Intel[®] 80303 and 80302 I/O Processors

Specification Update

March 2007

Order Number: 273355-011US

1. Title Page revision number

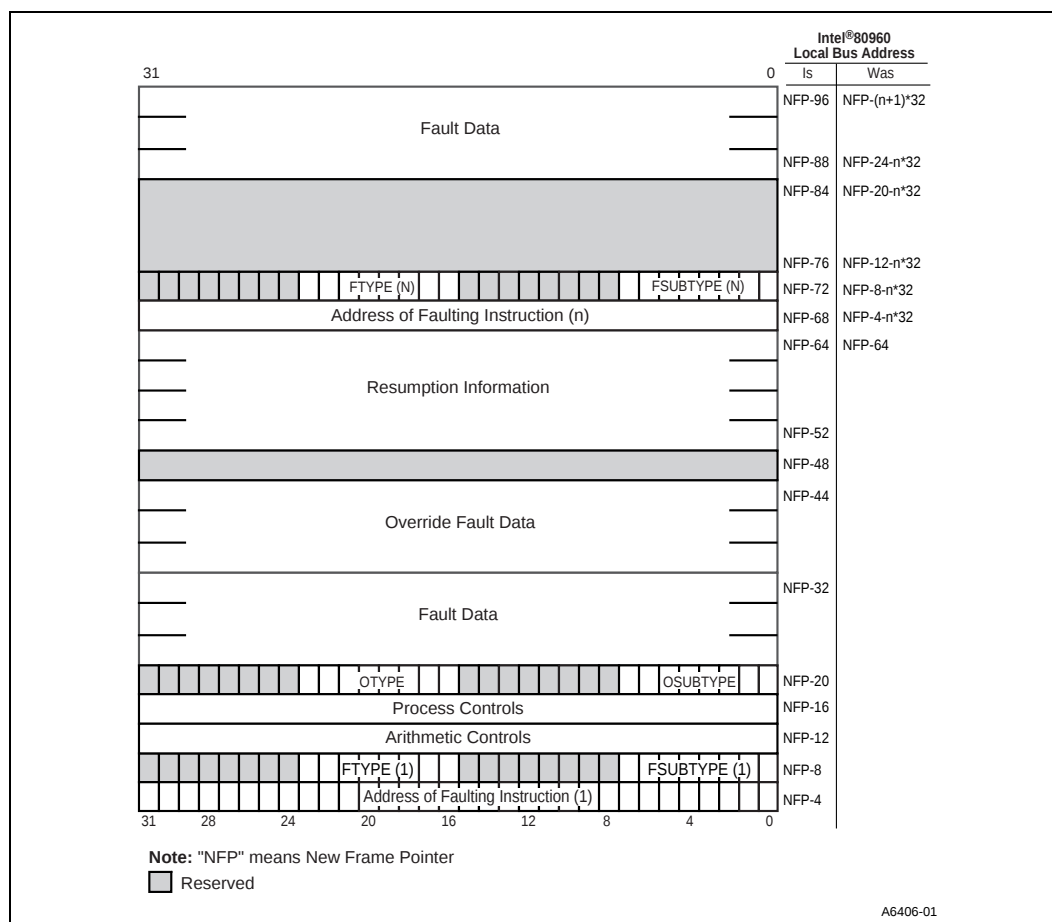
Problem: Manual indicates Revision 0.5.

Workaround: This type of revision numbering is not used with published documents. Refer to the Document Number 272353-001. The extension -001 is the correct revision number for this document.

Ignore revision number 0.5.

3. Figure 13-22 on page 13-40 did not print correctly

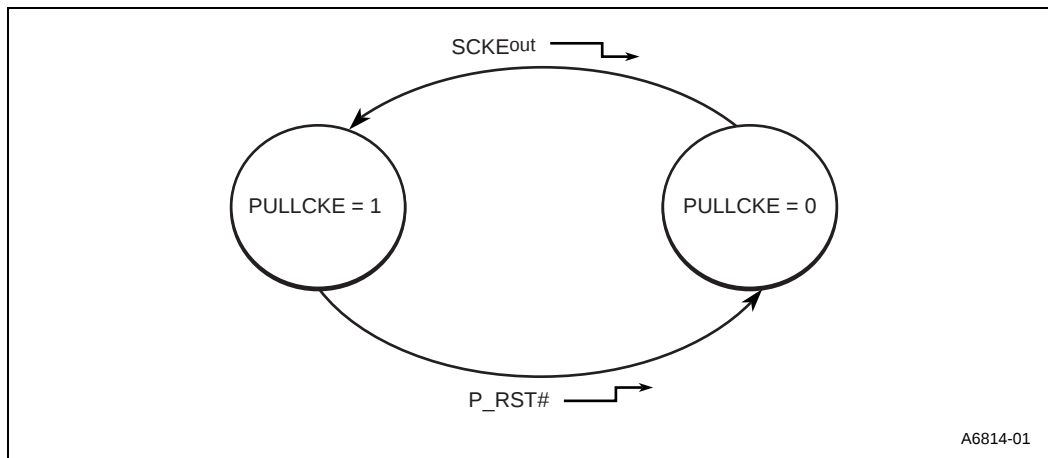
Problem: Figure 13-22 on page 13-40 did not print correctly.

Workaround: Replace Figure 13-22 with the following:

4. Figure 13-18, page 13-35

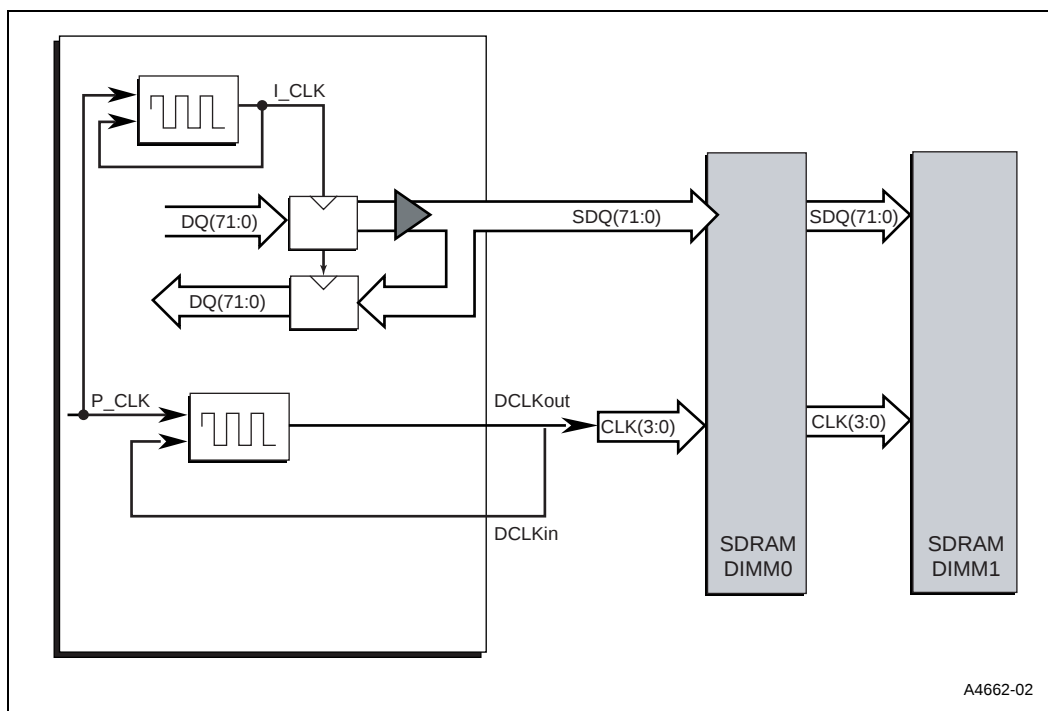
Problem: Replace Figure 13-18 with the following:

5. Figure 15-2 on page 15-3 did not print correctly

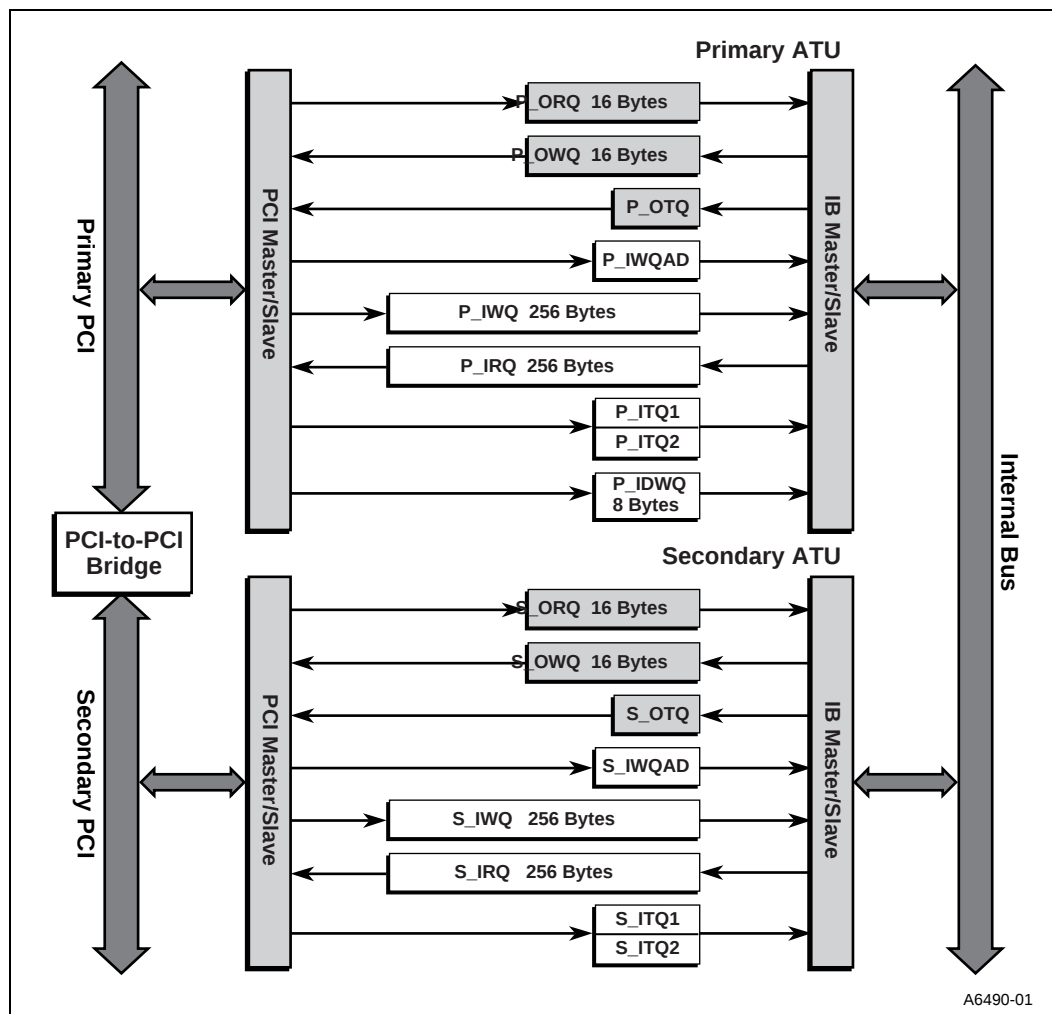
Problem: Figure 15-2 on page 15-3 did not print correctly.

Workaround: Replace Figure 15-2 with the following:

9. Figure 25-1 on page 25-1 has incorrect data

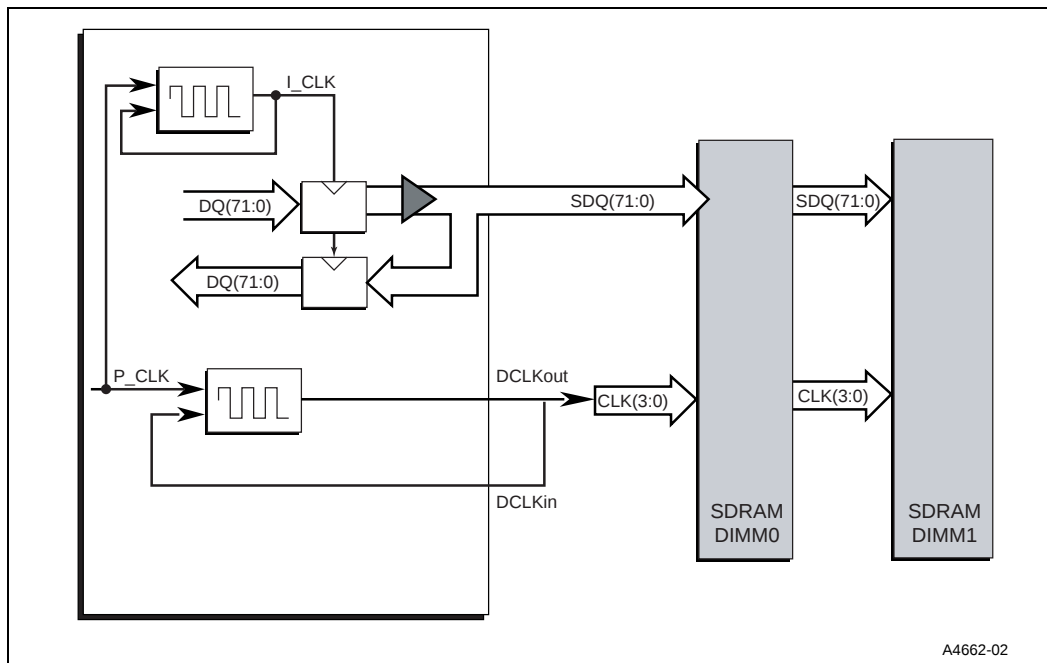
Problem: The Internal bus in diagram shows 66 MHz bus speed. The actual bus speed is 100 MHz

Workaround: Replace Figure 25-1 with the following:

11. Figure 25-2 on page 25-2 did not print correctly

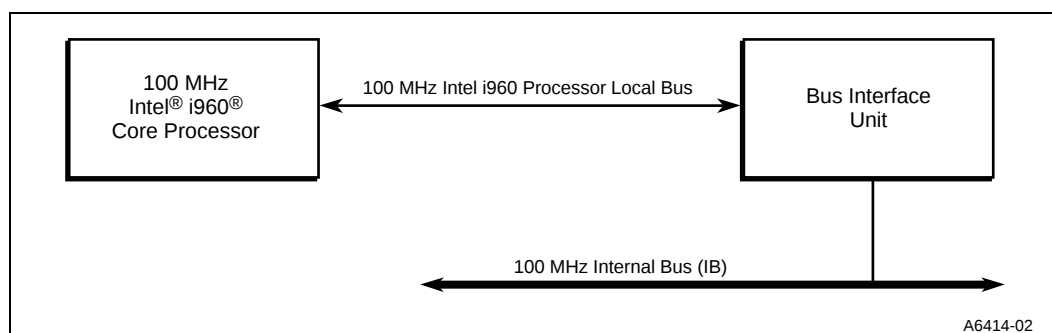
Problem: Figure 25-2 on page 25-2 did not print correctly.

Workaround: Replace Figure 25-2 with the following:
